REVISED ADDENDUM TO AN ADOPTED ENVIRONMENTAL IMPACT REPORT

Project Name and Number: Curtis Park Village Fuel Center Project (P14-036)

Curtis Park Village Fuel Center Project (P14-036)
Revised Addendum to Environmental Impact Report (SCH 2004082020)

To: Tom Buford, Senior Planner
From: Samar Hajeer, Senior Engineer
Subject: Curtis Park Fuel Station (P14 -036) □ Buchanan Street Location Traffic Evaluation
Date: 11/6/2015

Figure 4
Circulation Issues

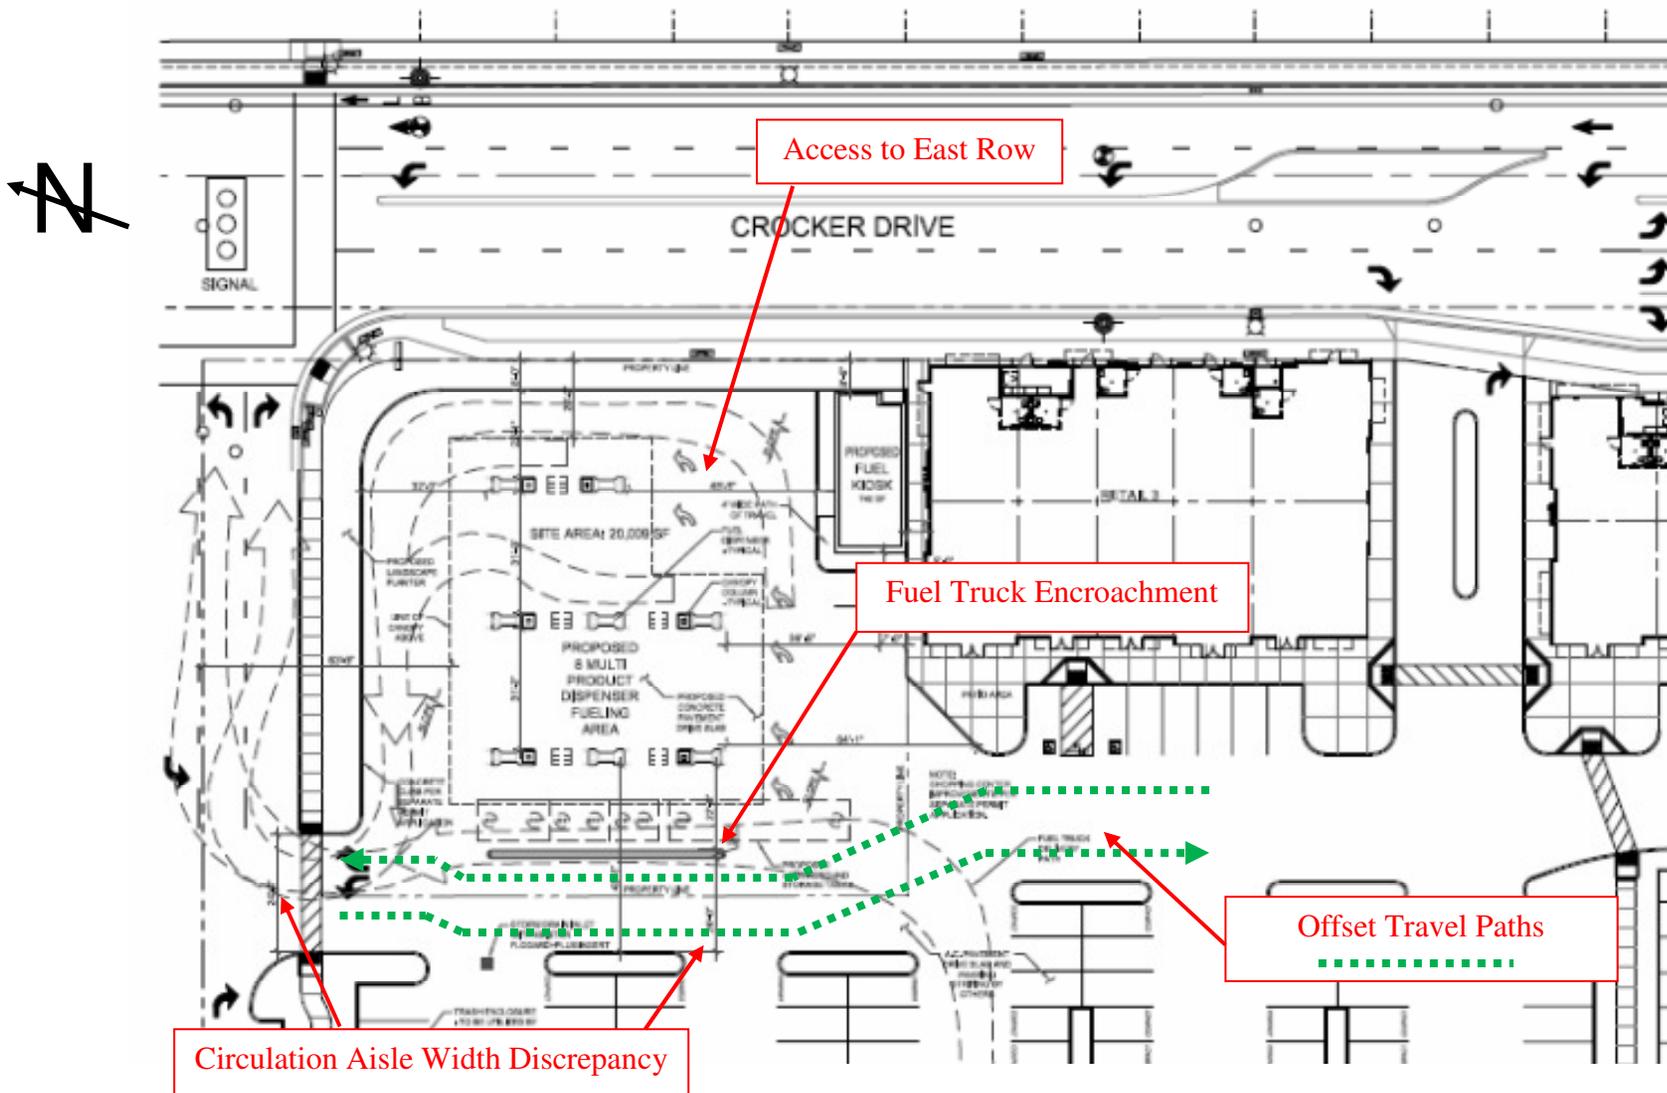
The following issues have been identified, as shown on Figure 4:

- There is a discrepancy on the plan, regarding the width of the north-west circulation aisle. Two dimensions, different in physical length, are shown as 24 feet.
- The fuel truck position is shown encroaching into the circulation aisle. Based upon the earlier referenced TJKM report, up to three fuel truck deliveries may occur per day.
- Access to the east row could be blocked by vehicles queued at the center and west rows.
- Vehicles in the north-south circulation aisle traverse an offset alignment.

The following plan modifications and operational strategies are recommended:

2. Revise the fuel truck location such that the fuel truck does not encroach into the circulation aisle.
3. Provide signing and striping to California MUTCD 2014 Edition Standards. This should include one-way and do not enter signage, as well as stop bars at the exit of the fuel area (at the circulation aisle).

5. In the event that queuing exceeds the area between the fuel area and the circulation aisle, it may be necessary to dedicate an area (lane[s]) for queuing. This may result in the disruption of parking access during such periods. Figure 5 identifies a potential area for overflow queuing, which shall be monitored by the applicant. Fuel ambassadors shall be used for manual traffic direction and control.

Originally Proposed and Revised GDF Locations
 Safeway Fuel Center
 Crocker Road

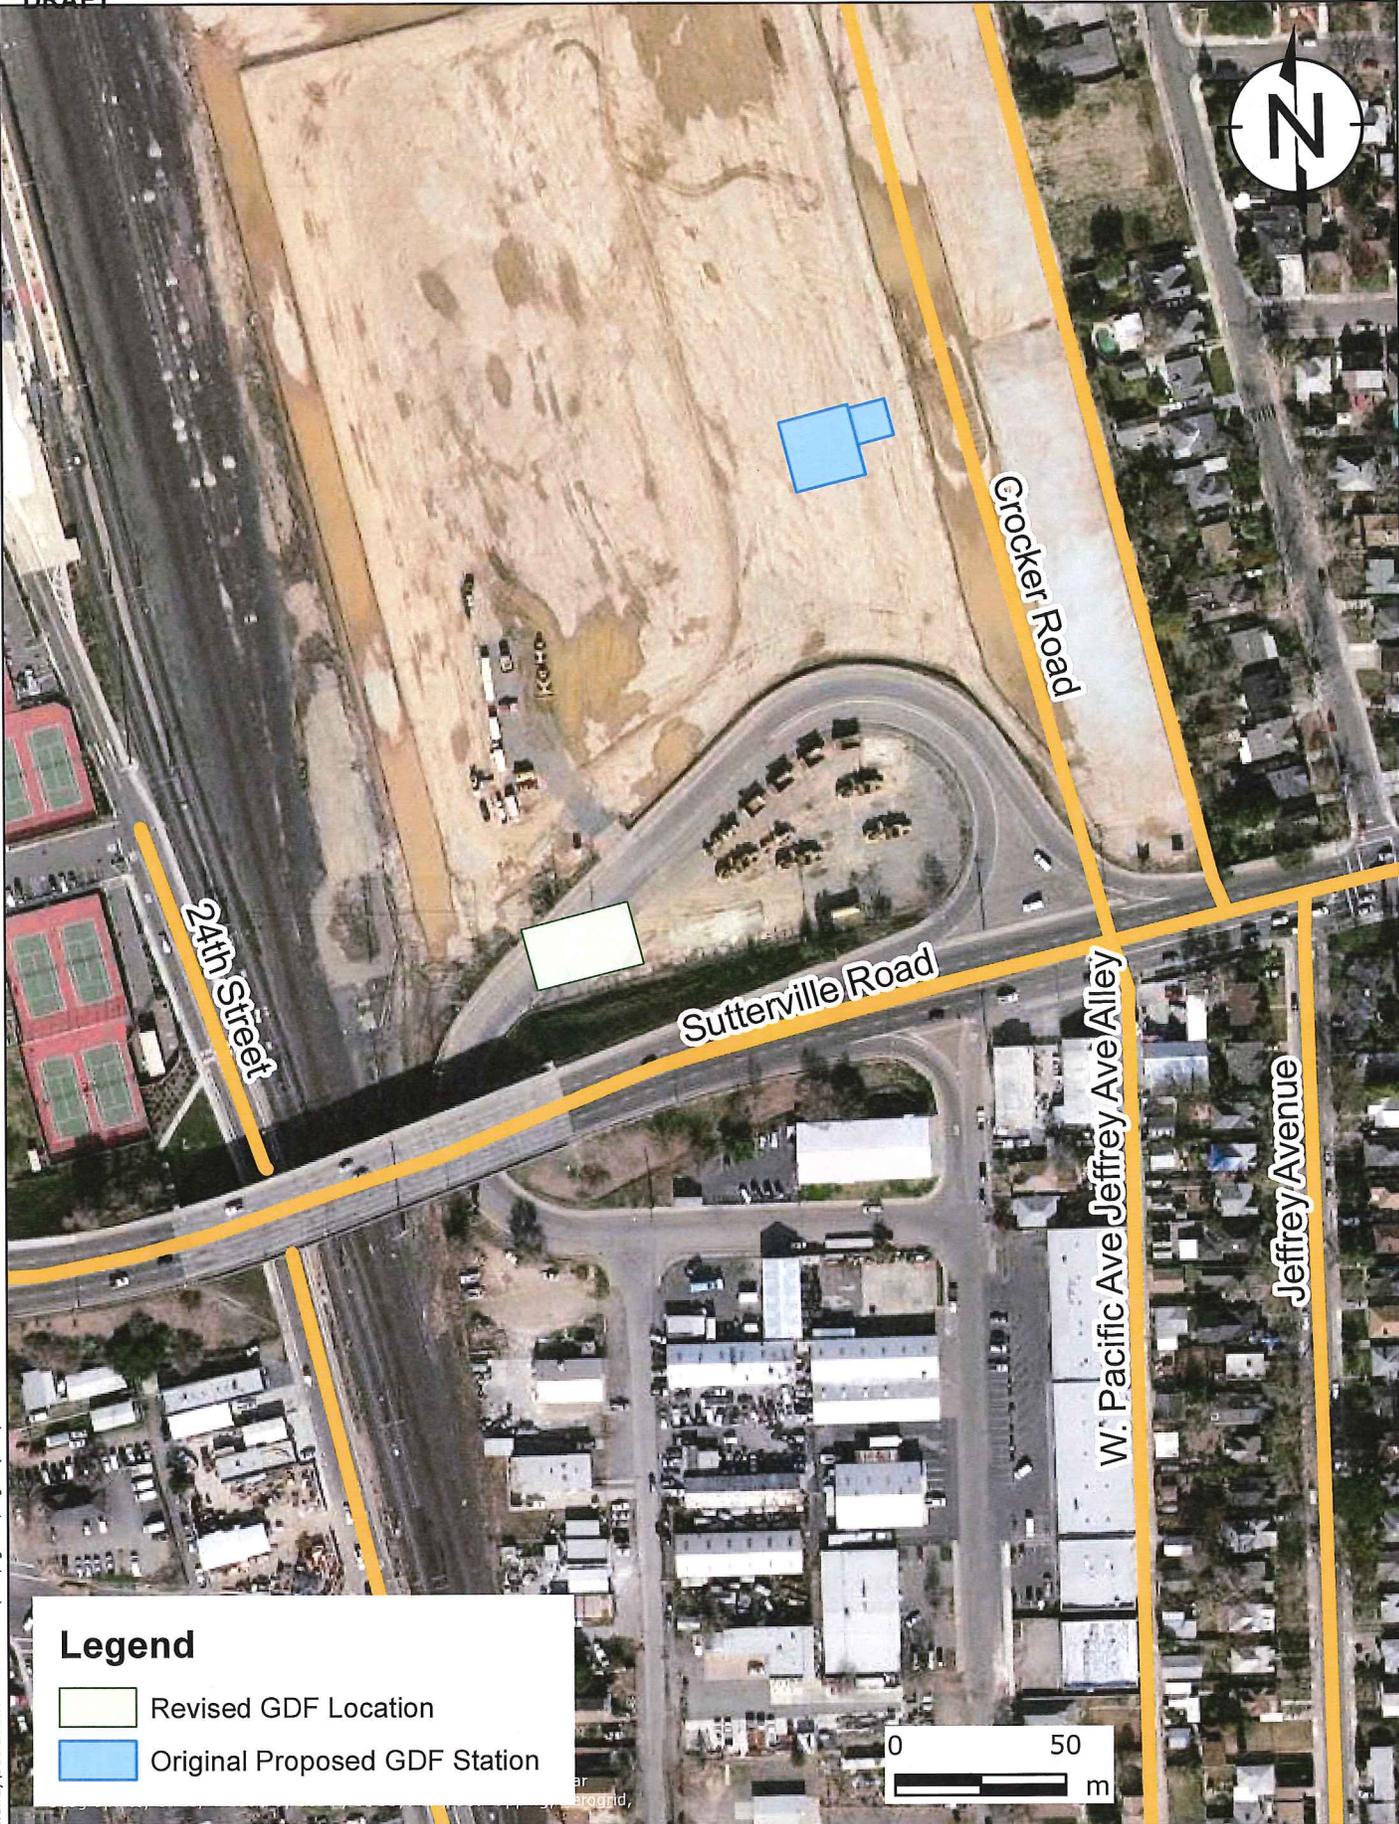
Since the preparation of the HRA, we understand that Petrovich Development Company is proposing a revised location of the fuel center such that it will be further from the new homes to be located to the east on Crocker Drive. Figure 1 shows a comparison between the previous site and current site plan for the GDF. The previously identified maximally exposed individual residents (MEIR) for cancer risk, chronic health index (HI), and acute HI were located at the new homes on Crocker Drive. These residential receptors were as close as approximately 80 feet from the previously sited GDF.

This revised location will very likely result in lower estimated health impacts. It is about 400 feet further from residents in the predominant wind direction, compared to the initial site location. (The wind rose (Figure 2) indicates that the predominant wind direction is from the south west.) This will result in lower cancer risk, chronic HI, and acute HI. Based on Bay Area Air Quality Management District (BAAQMD) scaling methodologies for gas stations, this additional distance could reduce impacts by as much as 90%. SMAQMD does not have similar guidance, but we believe the BAAQMD guidance can be used to provide a reasonable estimate of the reduction in impacts. The new proposed location is closer to the community college to the east, but the community college location is still 400 feet away, which is further than the original maximally impacted receptors, and is not a residential location, further lowering health impacts. In addition, the community college is not in the predominant wind direction and therefore we believe that risks would be lower in this location than at the original MEI.

In summary, based on our professional judgment, we believe the health impacts resulting from air emissions would be lower at the new site than at the site originally evaluated. In order provide a quantitative estimate of the reduction, further dispersion modeling would be required. SMAQMD may require a revised HRA for permitting purposes if this location if finalized.
